Solicitation: 36C78626B0002

Project: Biloxi National Cemetery Expansion

RFI- Contractor Questions & Government Responses

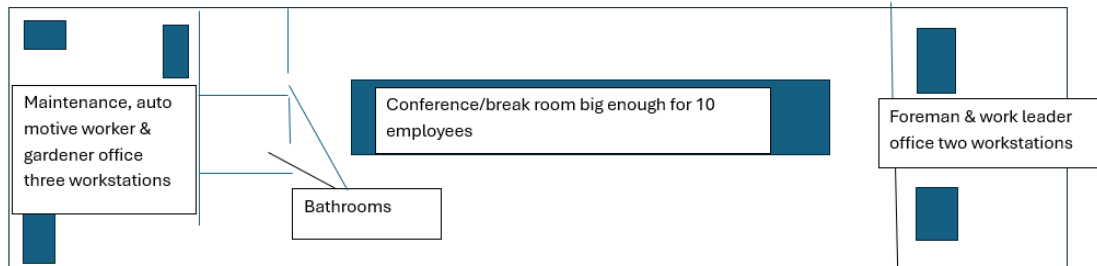
43. Please specify the work/operational hours of the Cemetery.

a. **Response – 8:00am to 5:00pm.**
